Thursday, March 25, 2021

*F.1. Bylaw for 1150 Cook Street: Development Permit with Variances Application No. 000130

1150 Cook Street
Development Permit with Variances #00130

Gas Meter Enclosure Sc. 1:50

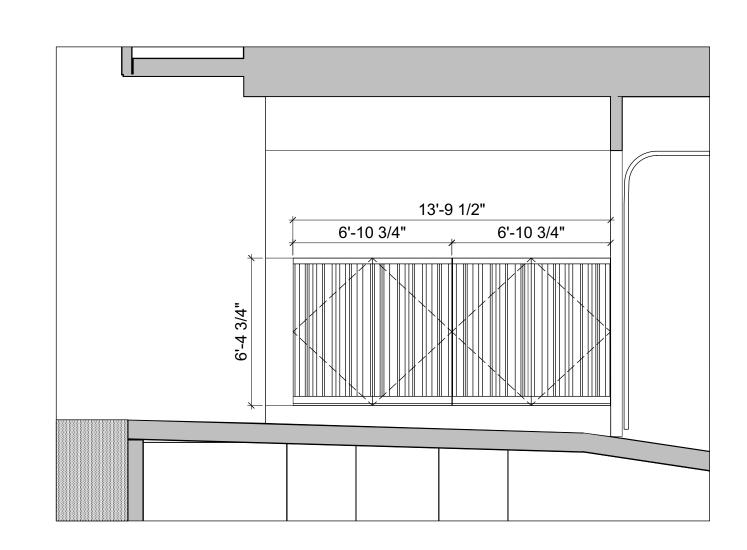
- a. Further consideration for the location of the gas meter on Cook Street and provision of additional detail for the design of the metal fence enclosure, to the satisfaction of the Director of Planning.

- a. Further consideration for the location of the gas meter on Cook Street and provision of additional detail for the design of the metal fence enclosure, to the satisfaction of the Director of Planning.

New buildings should be designed to relate well to public streets and sidewalks and have quality architectural materials and detailing in building bases and street walls. Staff have noted the limited and inconsistent detail provided on the architectural elevations, renders and material sheet, and recommend that these items be corrected prior to the application being considered for an Opportunity for Public Comment. In particular, the site plan indicates a gas meter that occupies a prominent location on the Cook Street frontage, with "decorative metal gates" but insufficient detail has been included on the elevations to fully review this aspect of the design. Staff recommend the location of the gas meter be revaluated to ensure a positive street relationship along Cook Street.

Hinged swinging double gate with:
- extruded Aluminum tube framing

- custom flat bar grille (bars welded to supporting frame)
- electrostatically applied powder coating (colour to match surrounding wall finish)
- anti-intruding fatseners
